TO :	«List1256LMSEP_CDR_Roof_Ventilation_Sy»	**FROM:**	COUNCIL FOR DEVELOPMENT AND RECONSTRUCTION BEIRUT – LEBANON
FAX N°:	«FAX»	**FAX N°:**	(961-1) 981 252 - 981 253
SUBJECT:	Roof Plant Heat Extraction- Ventilation System for the Roof of CDR s Building. Ref Nb: LMSEP/AFESD/W3 **Addendum No. 2 & Postponement of Bid Submission date**	**REF:**	2639/1
DATE:	29/10/2026	**N° OF PAGES:**	INCLUDING COVER SHEET (4)

Please find attached **Addendum No.2** related to the tender document for the above – referenced project.

Response to Tenderers Queries
ROOF PLANT HEAT EXTRACTION – VENTILATION SYSTEM FOR THE ROOF OF CDR's BUILDING

DETAIL OF CABLE INSTALLATION FROM CABLE TRAY TO
DISCONNECTING SWITCH OF FAU

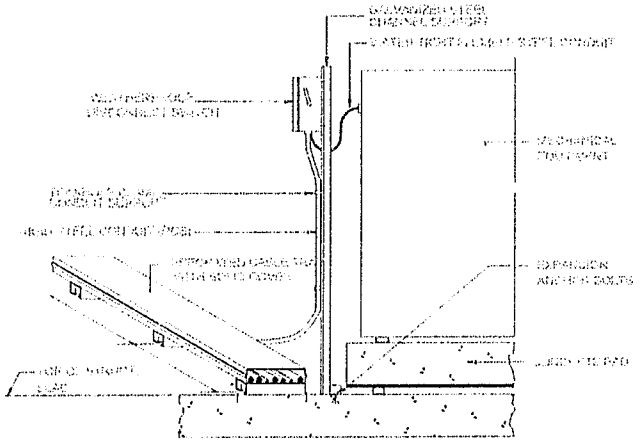
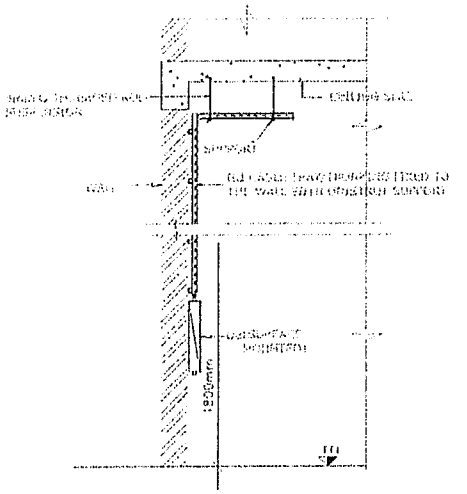
Query6: Conduit type — Electrical Specifications, Section 2, and Drawing E-001: ask for galvanized steel conduit on the vertical support connecting the Disconnected Switch to the horizontal cable tray, this specific detail drawing appears to be intended for a pump installation. Please clarify whether rigid heavy-duty PVC conduit is acceptable for the scope (involving exhaust fans installation)

Query8: Vertical supports for exhaust fans — Drawing E-001 and Mechanical BOQ, Part 3, Item 2.1.2: Please confirm whether the supply and installation of these vertical supports for all eleven exhaust fans should be included in the disconnect switch price item rate.

Reply6: Rigid heavy-duty PVC conduit is not accepted for this installation. Refer to the updated detail, E-001 which shows rigid metal conduit from the cable tray on the inclined roof to the disconnecting switch, and flexible metal conduit from the switch to the exhaust fan. No separate galvanized steel vertical support is required under this detail

Reply8: Refer to the updated attached electrical installation detail E-001 Titled "DETAIL OF CABLE INSTALLATION FROM CABLE TRAY TO DISCONNECTING SWITCH OF FAN". The separate galvanized steel vertical supports shown in the previous detail are no longer required. The local conduit installation from the cable tray to the isolating switch and from the switch to the fan, including the necessary fittings and fixings, shall be included in the respective isolating switch unit rate.
